STATE OF WASHINGTON  
DEPARTMENT OF ECOLOGY

March 2, 2000

Re: *Quarterly Notification of Class 1 Modifications to the Hanford Facility Resource Conservation & Recovery (RCRA) Permit, Dangerous Waste Portion (Quarter Ending December 31, 1999 - Condition I.C.3)*

**Hanford Facility RCRA Permit Modification Notification Forms  
for  
305-B Storage Facility  
Part III, Chapter 2, Attachment 18**

Chapter 7, Figure 7.3:

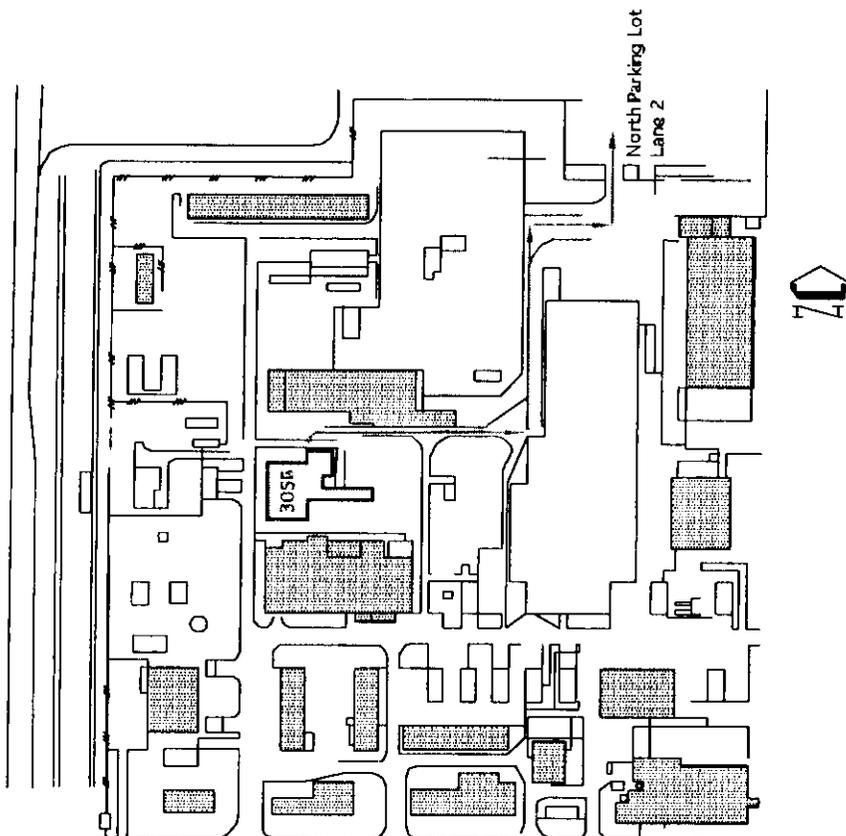
### Hanford Facility RCRA Permit Modification Notification Form

Description of Modification:
